*Date:* JUN 01 2010  
*Refer To:* EP2010-0268

**Subject: Request for Deviation from the Approval with Modifications Phase III Investigation Work Plan for Material Disposal Area C, Solid Waste Management Unit 50-009, Revision 1**

Figure 1: Regional Aquifer Well Locations

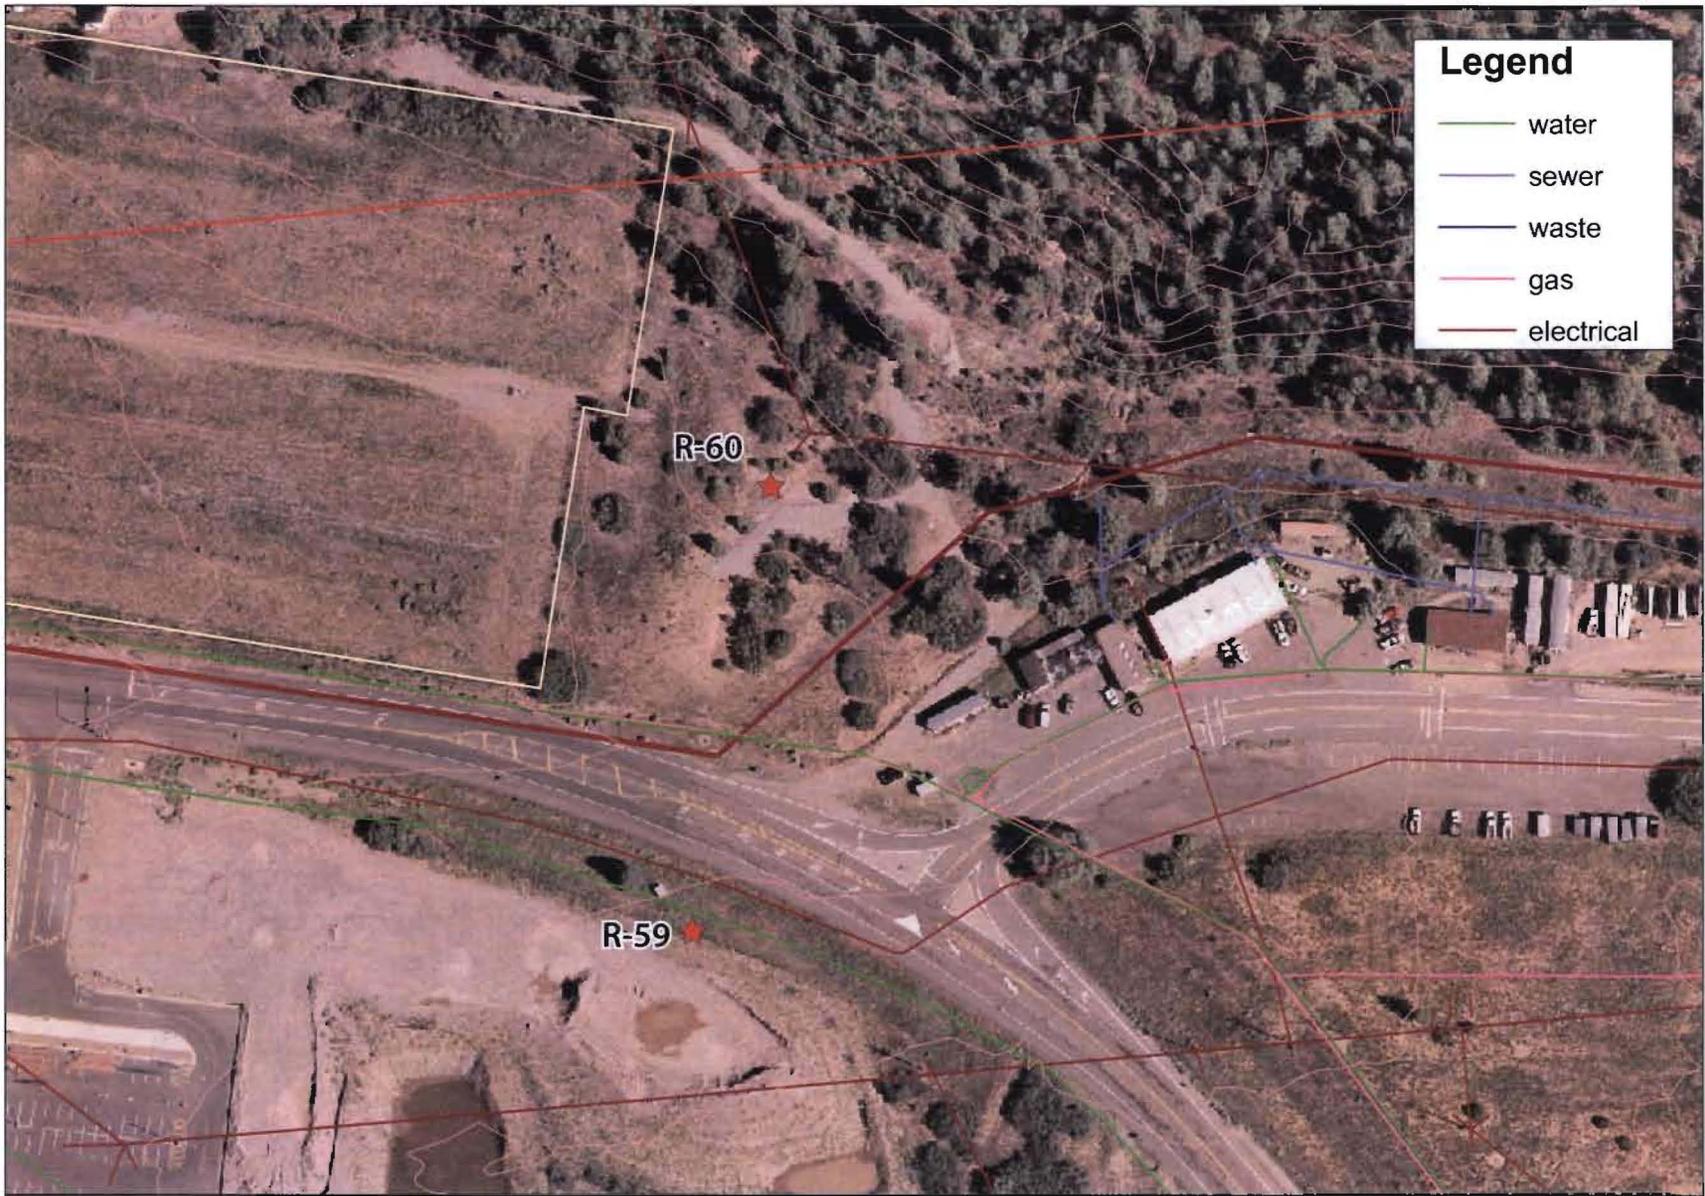
Per Section 4.3.1, Well Locations, of the approved work plan, "NMED requires that the southern well be drilled first and that water-level data and any other pertinent information collected from this well be used to revise the location of the northern well, if necessary. Any proposed change to the well location will be submitted to NMED for review and approval." The regional aquifer well locations are shown in Figure 1.

On May 26, 2010, the Los Alamos National Laboratory (the Laboratory) and NMED personnel performed a field walk-down of the proposed southern drilling site for regional aquifer well R-59. During the walk-down, construction personnel confirmed the location surrounding R-59 is scheduled to be regraded and paved as part of a parking lot and road upgrade project near the intersection of Pajarito Road and Puye Road (Figure 2). The heavy traffic and congestion from construction equipment and haul trucks used for the upgrades precludes access to the area for the drilling crews.

Because of the change in field conditions, the Laboratory requests concurrence from NMED to drill the northern well, R-60, before installing R-59. As discussed with your staff during a May 27, 2010, teleconference, the Drilling Work Plan for Regional Aquifer Well R-60 will be submitted to NMED on June 1, 2010.
